**CITY OF JONESBORO**  
**Jonesboro Historic Preservation Commission**  
**124 NORTH AVENUE**  
**February 17, 2020 – 5:30 PM**

Historic Preservation Commission to consider a Certificate of Appropriateness for 106 South Main Street; Parcel No. 13241D C003; Renovation to existing commercial building.

Agency recommendation – **Approval of exterior renovation**; The former law at 106 South Main Street (Ferguson building) has been undergoing extensive interior renovations for its new owner, in order to convert it into a two-story Mexican restaurant with a rooftop bar. The property is zoned H-1 (Historic District) and is in the Downtown District on the block known informally as “lawyers’ row.” While this specific building unit is not on the Historic Register, it is a contributing building to the Historic District.

**2 Existing Rear Elevation**  
SCALE: 1/8" = 1'-0"

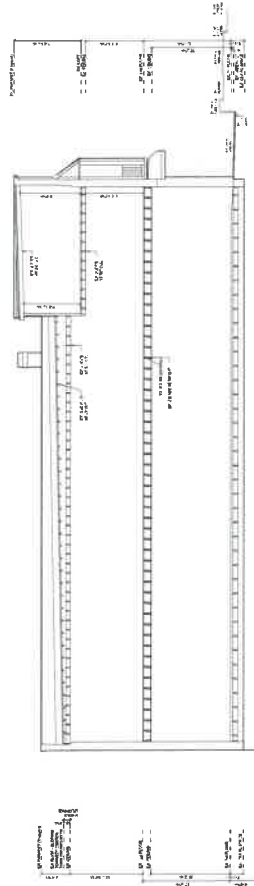
**Proposed changes to rear exterior**

- New window and door orientation
- Possible brick façade to match front brick
- New decks for first and second floors
- Outdoor seating area

5. *New windows on side and rear elevations shall be compatible with historic windows in terms of material, size and design. No windows present on the sides. The new rear windows will be compatible with the new modern windows at the adjacent Broad Street restaurant.*

(2) Additions. Alterations to existing properties are permitted when such alteration and additions do not destroy significant architectural or historical material. The design shall be compatible with the size, scale, color, material and character of the property and downtown area. **The only addition will be a cooler area at rear of the building, which will match the exterior of the rest of the building.**

**1 Existing Front Elevation**  
SCALE: 1/8" = 1'-0"

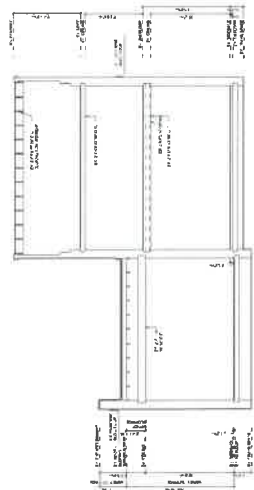
**Proposed changes to front exterior**

- New window and door orientation
- New awnings
- New signage on parapet
- Possible stack stone over existing brick on first floor
- Iron railing to be kept
- Portion of rooftop garden staircase enclosure will be visible over parapet

2. *The addition of architectural details where none existed before is discouraged. There are no proposed major architectural details on the front, except for stacked stone proposed to cover up the brick on the first-floor façade. This feature is not recommended for approval.*

1. *Historic building materials shall be maintained. Stacked stone proposed to cover up the brick on the first-floor façade. This feature is not recommended for approval.*
